**Re: Lot 23 Block 9 Unit 18
Volcano Cliffs, S.A.D. 228
6505 Picardia Rd. NW
Permanent C.O. – Not Accepted
Engineers Stamp Date: 9/14/2022 (D10D003I23)
Pad Certification Date: 11/13/2022
CO Certification Date: 2/14/2022**

DRAINAGE AND TRANSPORTATION INFORMATION SHEET (REV 6/2018)

ENGINEER'S SEAL	6505 PICARDIA	DRAWN BY WCWJ
	GRADING AND DRAINAGE PLAN	DATE 9-11-20
9/14/20	 <div data-bbox="2697 1815 2841 1835"> <i>Rio Grande Engineering</i> </div> <div data-bbox="2697 1839 2841 1857"> 1806 CENTRAL AVENUE SE SUITE 201 ALBUQUERQUE, NM 87106 (505) 872-0999 </div>	2102069-LAYOUT-9-11-20 SHEET # —
DAVID SOULE P.E. #14522		JOB # 2102069

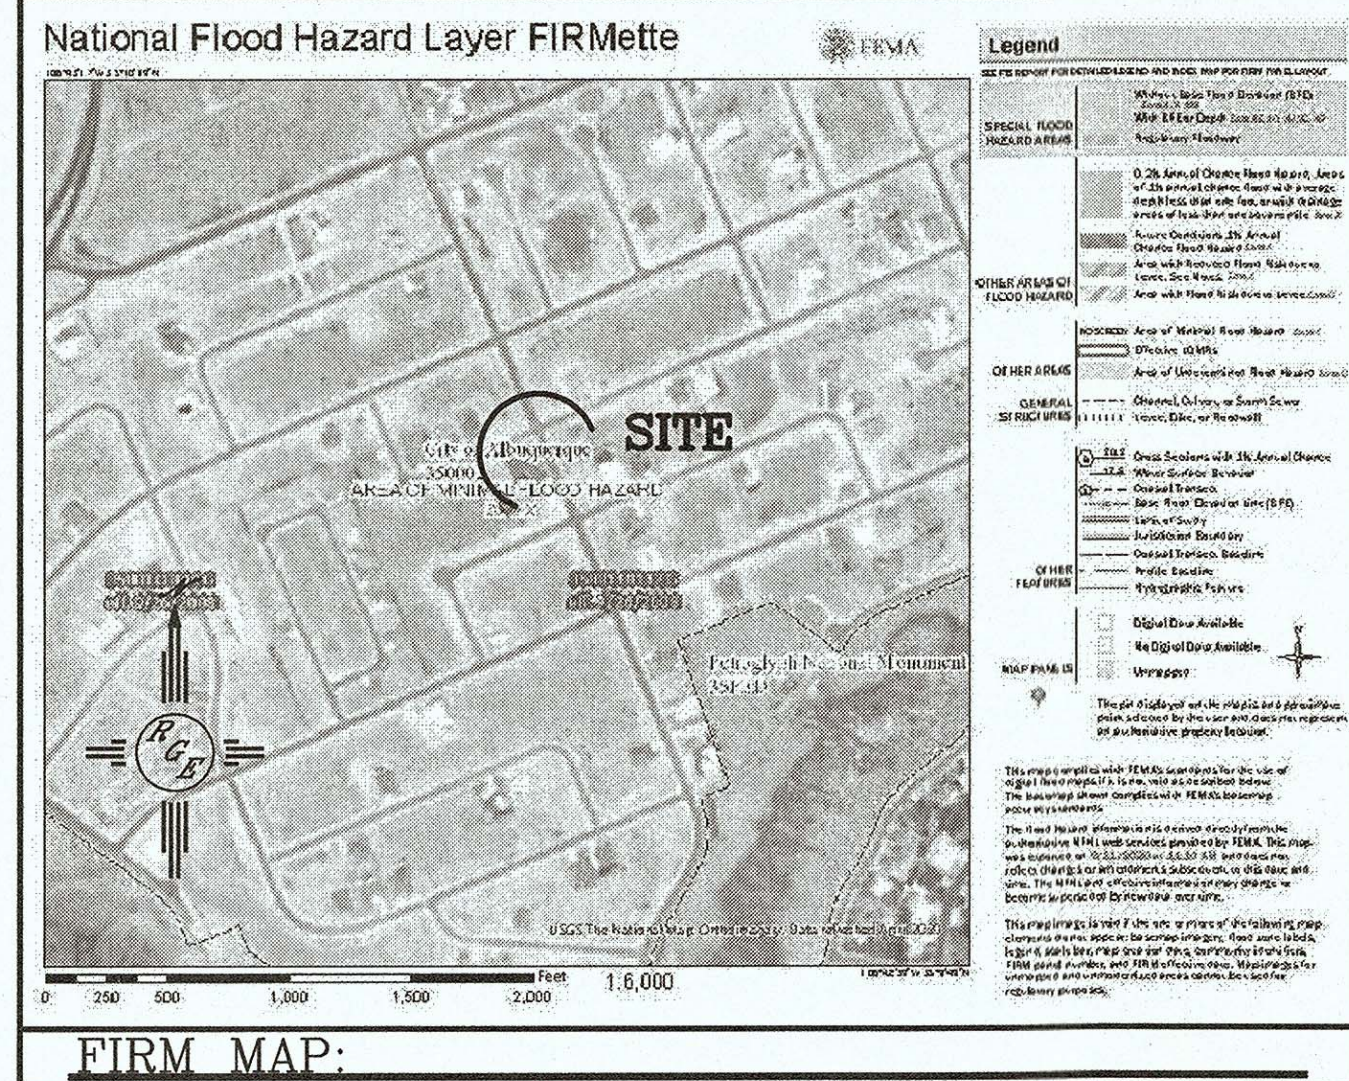
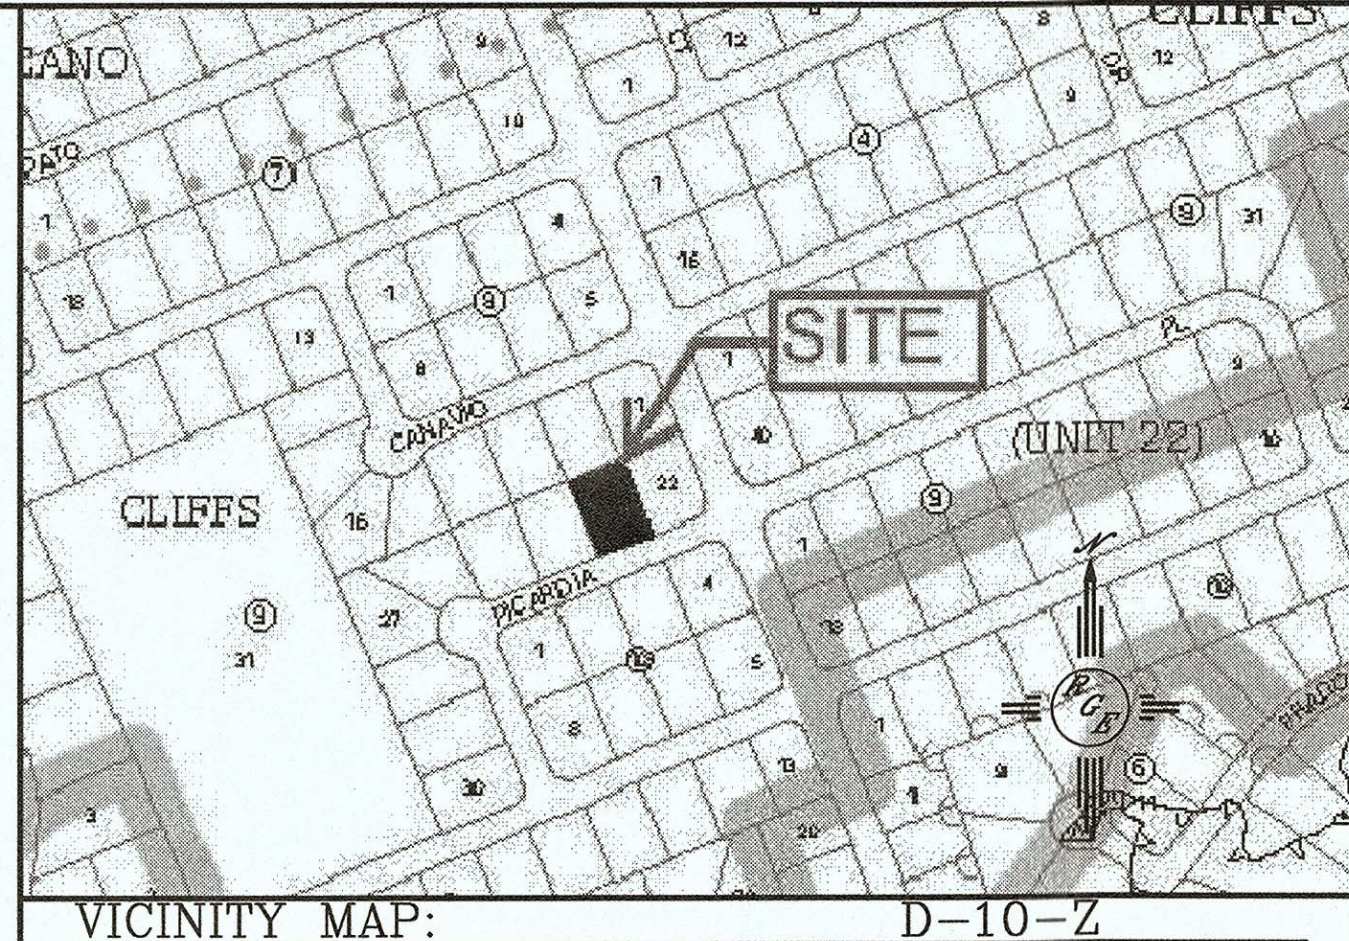
Based on the Certification received 2/15/2022, the site cannot be accepted for release of Certificate of Occupancy by Hydrology until the following comments are addressed.

- The bench mark needs to be replaced with a new monument cap.
